Comment (Annex 145B.1, page 281, line 21)

Figure 145B-X2—Staggered detection

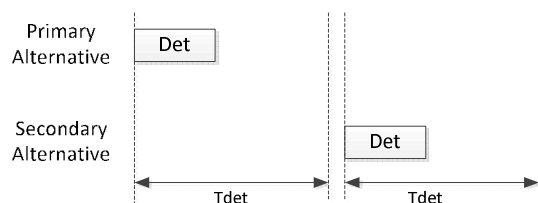
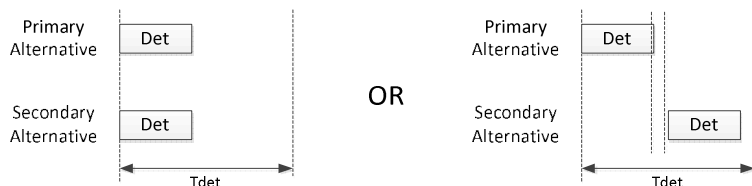
For clarity, to add drawings to Annex 145B.1 demonstrating the definition of parallel/staggered detection in 145.2.5.3 for CC_DET_SEQ.

Add the following text and drawings after line 21 on page 281.

Figure 145B-X1 shows a parallel detection, where detection occurs in the same Tdet window, and Figure 145B-X2 shows a staggered detection, where detection occurs in different Tdet windows.
